1 Reason for update

This update has been made to allow the PMU's CAN address to be read and written from the configuration software. Prior to this update the CAN address had to be set using the CAN interface.

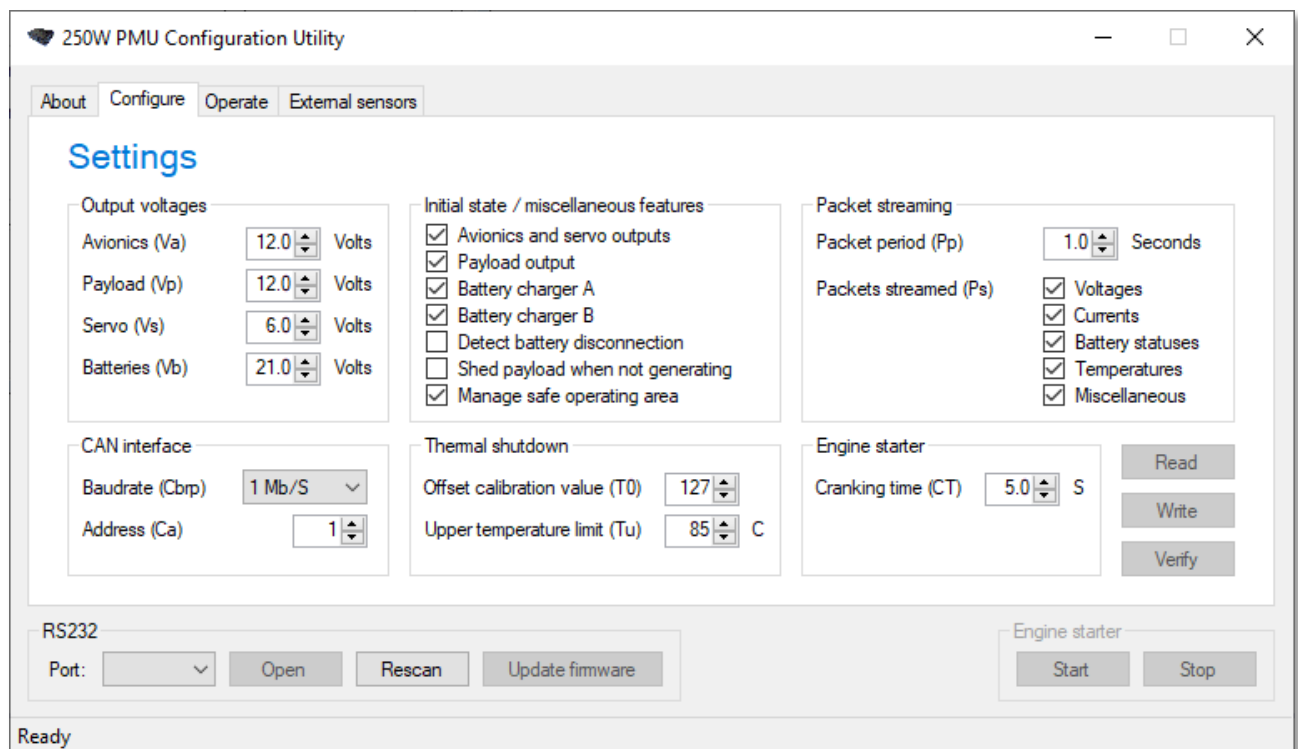
The configuration utility has been updated to version 1.0.0.7 and now allows the CAN Baudrate and CAN address to be set during configuration. The new items are located on the Configure tab as shown below:
